**WML0 – Retrofitting Loudspeaker Booster (Delivery Stop)**

Model Line: **Cayenne (9YA/9YB)**

Concerns: **Loudspeaker booster**

Information: **Due to worldwide semiconductor shortages experienced by some suppliers, the affected vehicles were built without a loudspeaker booster.**

*Loudspeaker booster*

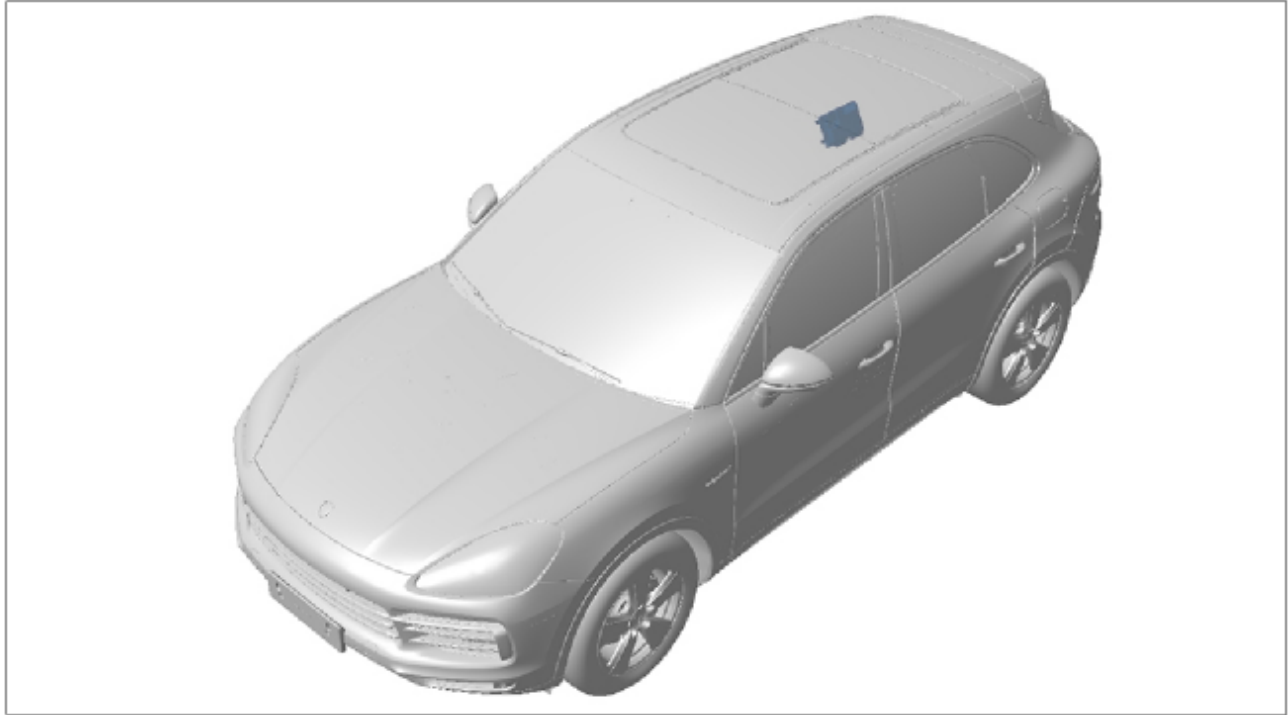
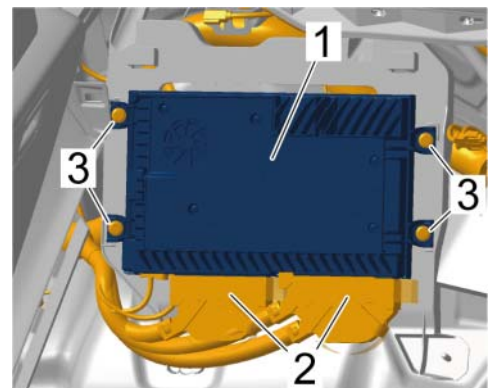
Action required: Retrofit loudspeaker booster.

2 Position loudspeaker booster ⇒ *Loudspeaker booster -1-*, screw in fastening screws ⇒ *Loudspeaker booster -3-* and tighten to **Tightening torque 6 Nm (4.5 ftlb.)** .

3 Plug in and lock electric plug connections ⇒ *Loudspeaker booster -2-*.
